**Colorado City Rest Area - Cuerno Verde - I-25 MM 74.39**  
**Elevation 5853'**

## Summary Observations

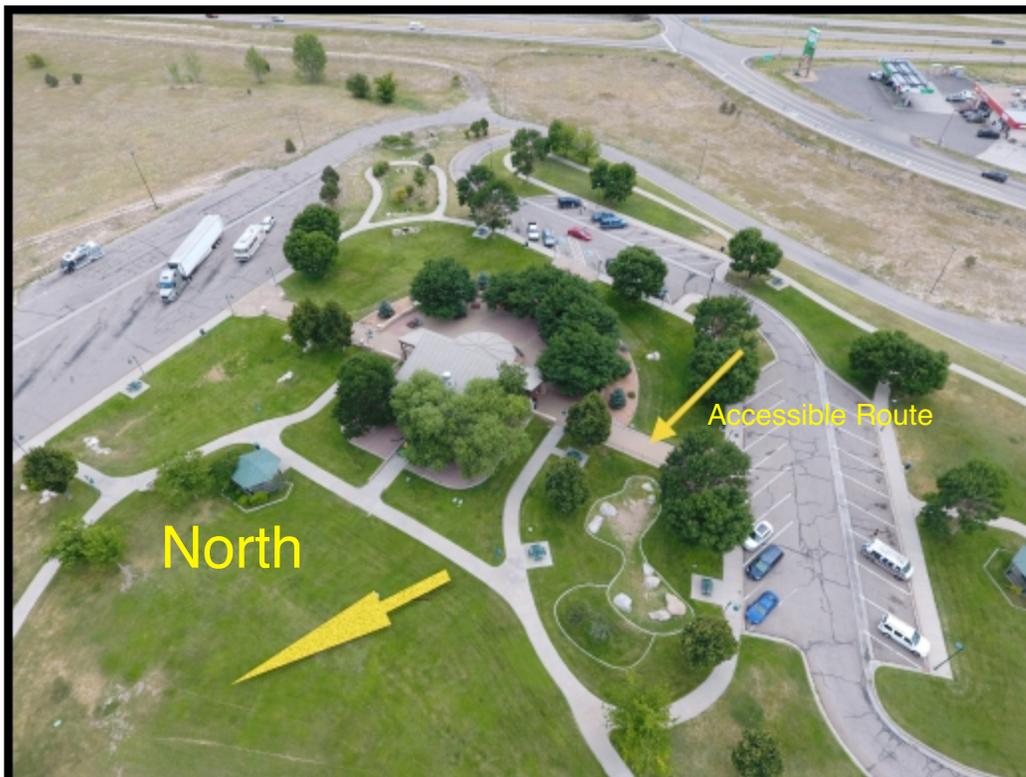
The route from the current accessible parking spaces to the building exceeds 8.33%. Suggest creating a new accessible route (**see small arrow in aerial photo above**) from two new parking spaces at the west side of the facility. This new designated accessible route has a modest slope with less than a 1:12 incline (approximately 6.5%). At the location of the current accessible parking spaces, add a directional sign with ISA (international symbol of accessibility ♿) - and an arrow pointing to the left/west.

#1 - raise signs to 80"

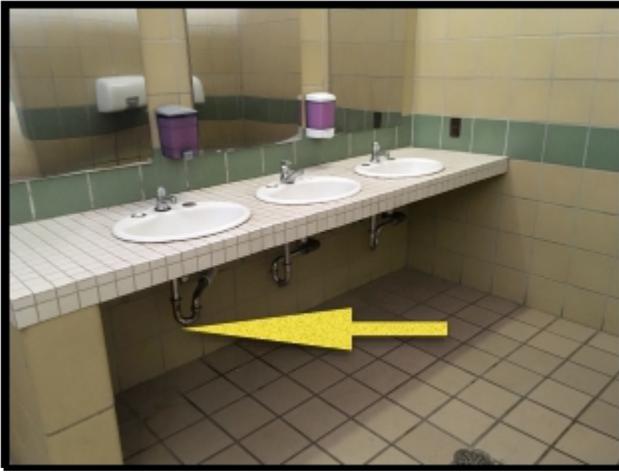
The two vertical parking signs should be raised to a minimum 60" with a recommended height of 80" for adequate clearance along the pedestrian route. See picture.

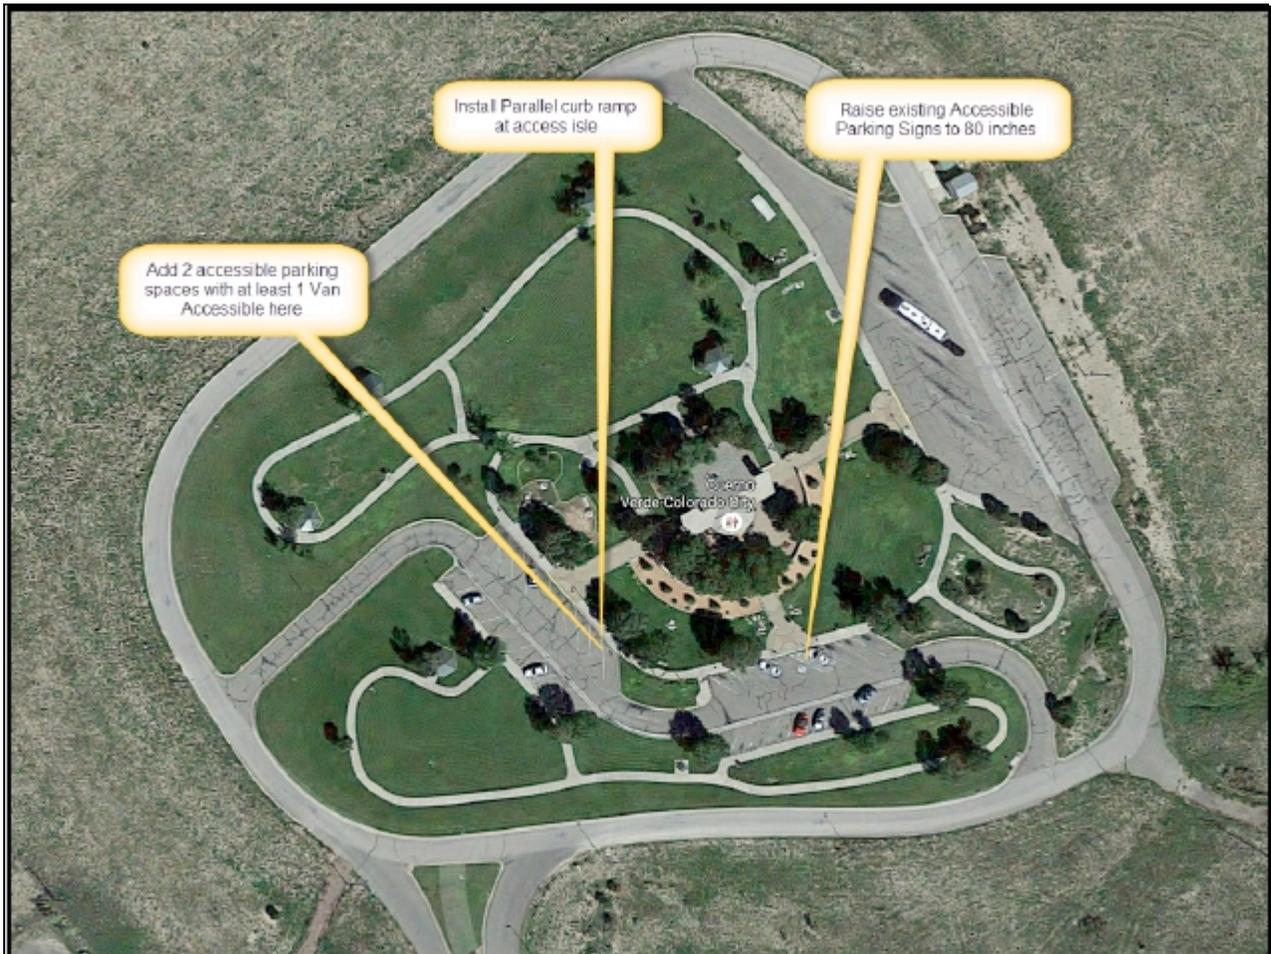
Too steep - 10.5%

Install Parallel curb ramp at access isle

Add 2 accessible parking spaces with at least 1 Van Accessible here

Raise existing Accessible Parking Signs to 80 inches
